## PRODUCT UPDATE- STANDARD LOCKERS

Effective with **new standard production lockers shipping after February 1, 2019, Lyon will be adding and changing some hole positions on the sides, backs, tops, bottoms, and shelves of the locker.** This will allow us to reduce the number of component sku's that we make, thus decreasing the number of setups and minimizing the complexity associated with scheduling.

E-181211-1

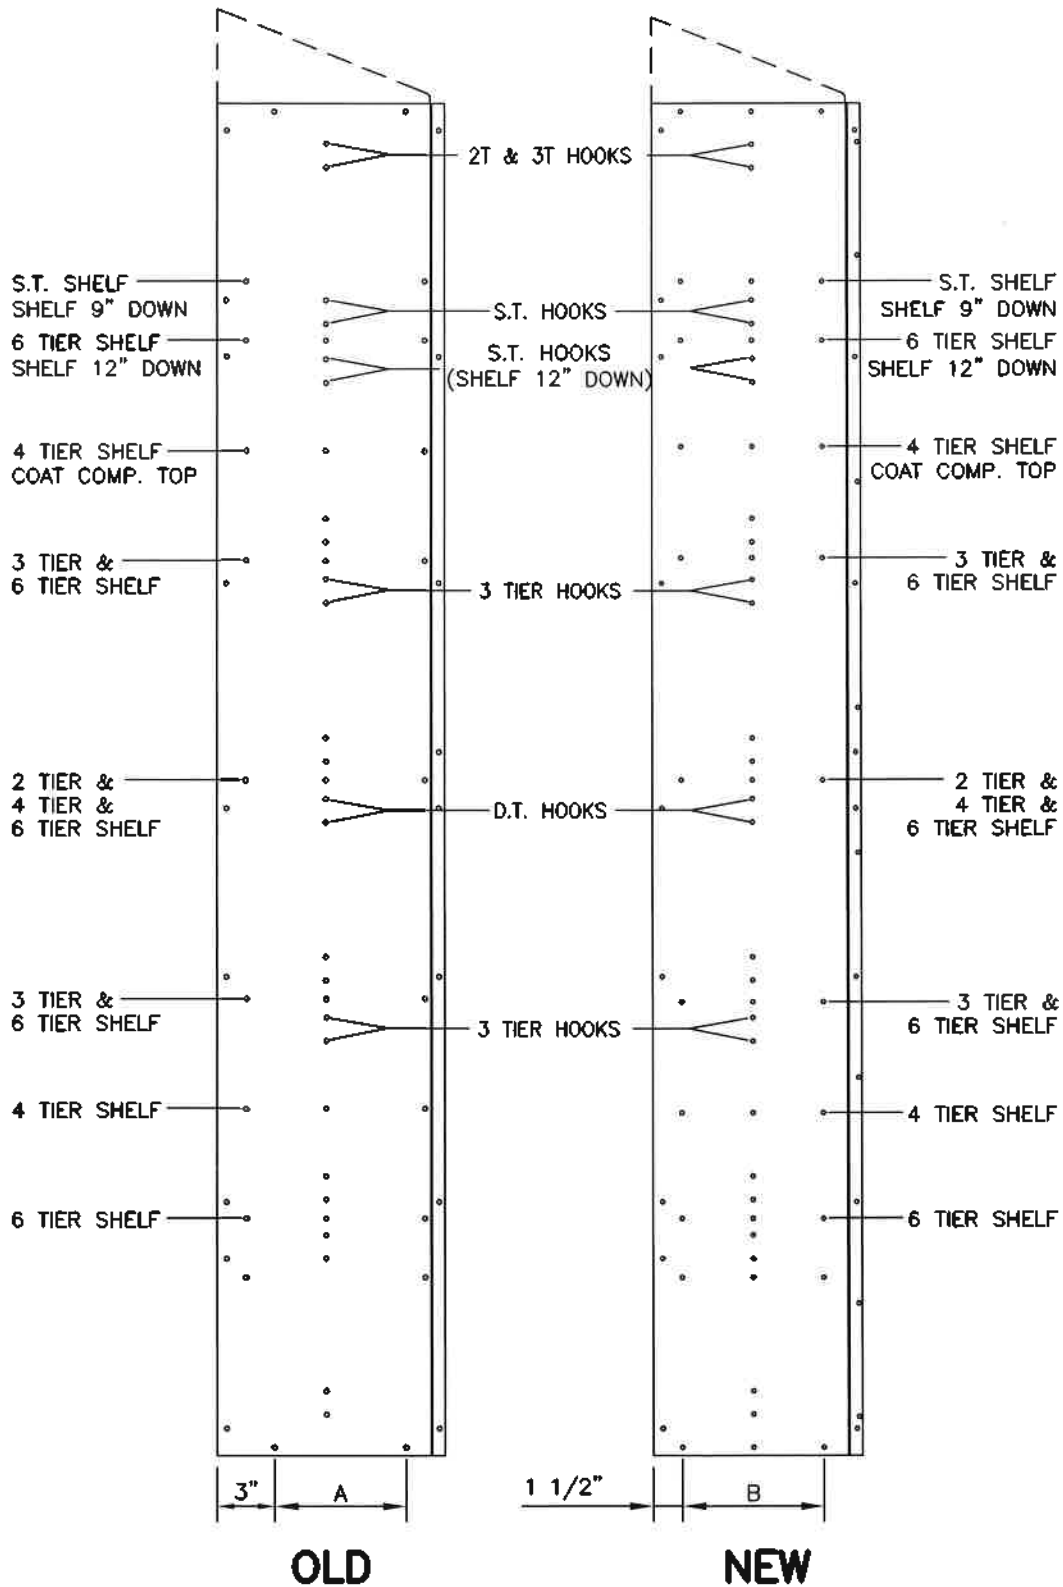
- This change is not backward compatible. That is, you will not be able to use the old sides, backs, tops, bottoms, or shelves on the new design unless you manually drill some holes.
- The change is partially forward compatible. That is, the new tops, bottoms, and intermediate bottoms can be used with the old locker design. However, the new side and back cannot be used on an old locker, again, unless you drill holes. We will still make the old style sides and backs for replacement parts.

# 72" SIDES

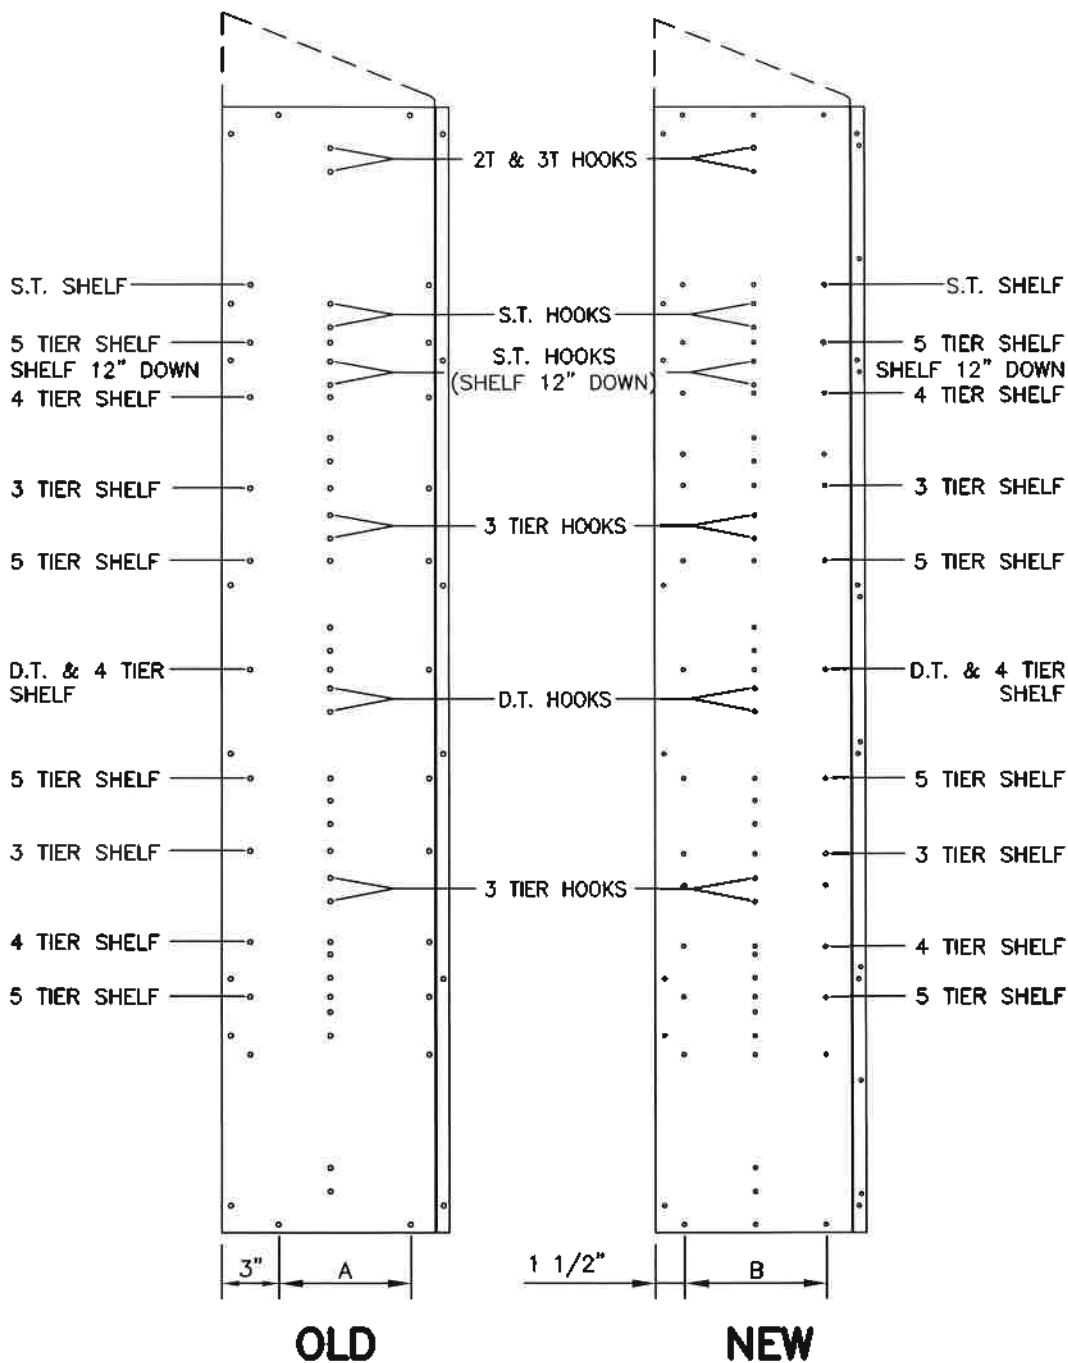
- 3 TIER AND 4 TIER PUNCHING WAS ADJUSTED VERTICALLY TO ACCOMMODATE ICM ON THE STANDARD SIDE
- TOP/BOTTOM AND SHELF PUNCHING HAS BEEN ALIGNED SO THERE IS A COMMON PUNCHING DIMENSION FOR TOPS, BOTTOMS, INTERMEDIATE BOTTOMS, AND SHELVES

# 72" BACKS

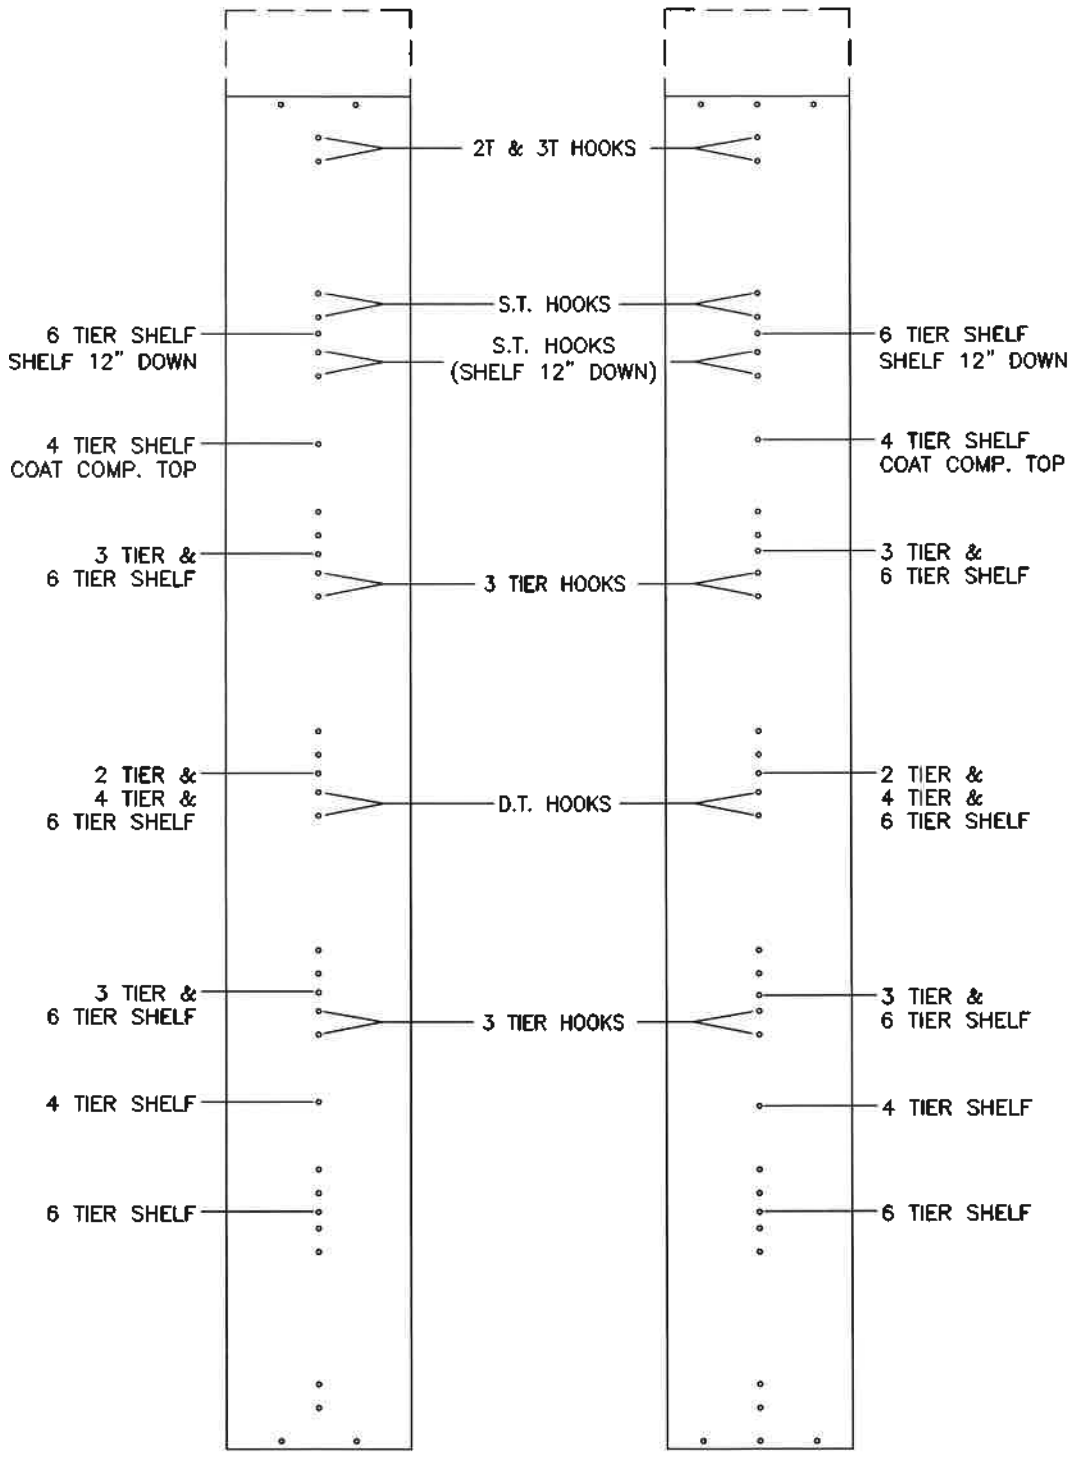
- 3 TIER AND 4 TIER PUNCHING WAS ADJUSTED VERTICALLY TO ACCOMMODATE ICM ON THE STANDARD SIDE
- CHECK DIMENSION ON SIDES TO DETERMINE WHICH STYLE OF BACK IS REQUIRED

# 60" BACKS

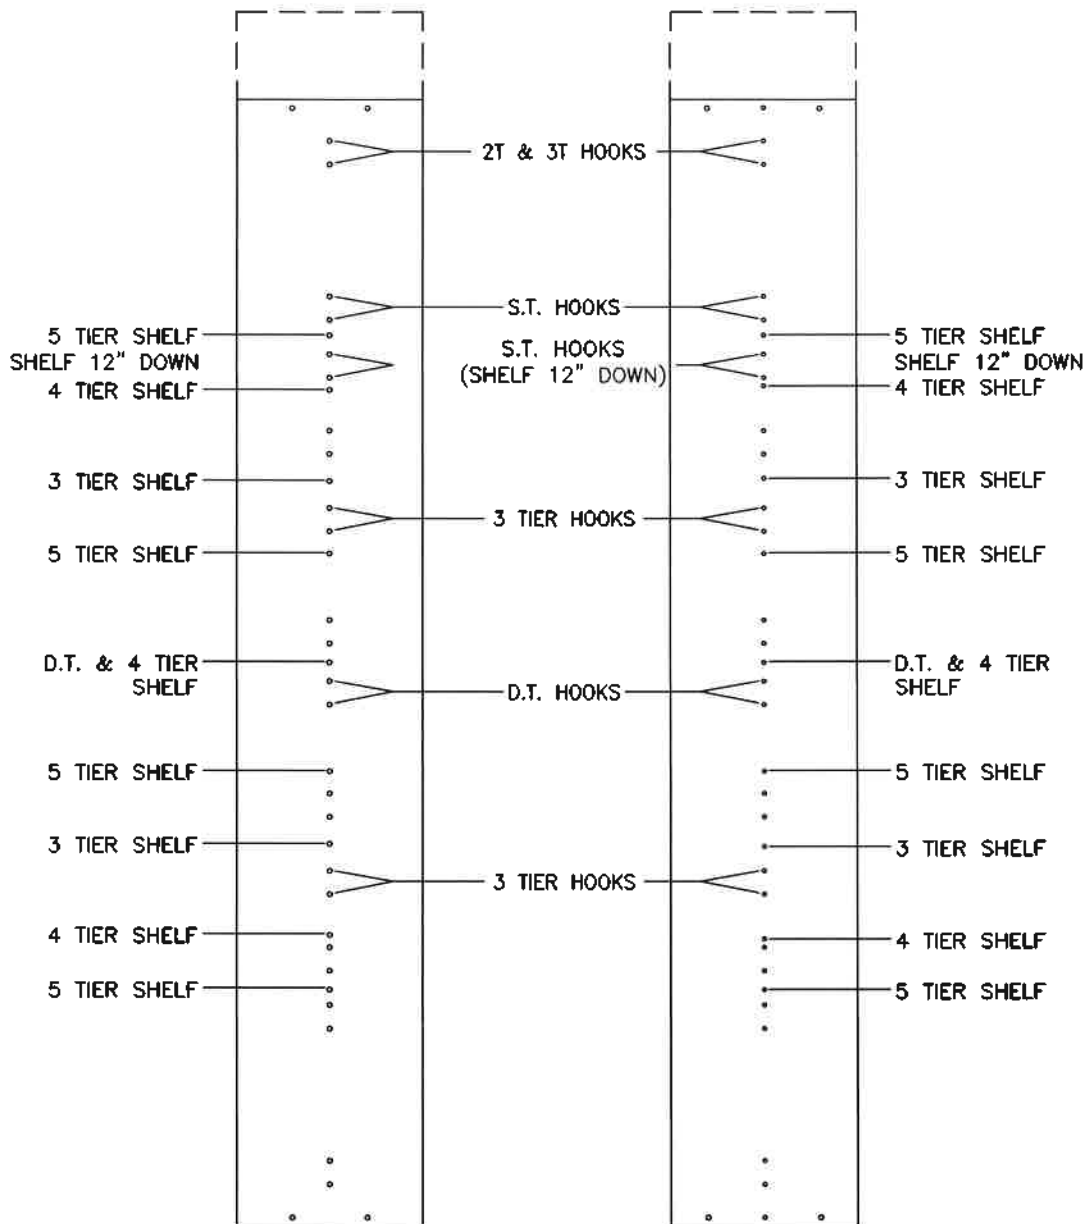
- 3 TIER AND 4 TIER PUNCHING WAS ADJUSTED VERTICALLY TO ACCOMMODATE ICM ON THE STANDARD SIDE
- CHECK DIMENSION ON SIDES TO DETERMINE WHICH STYLE OF BACK IS REQUIRED
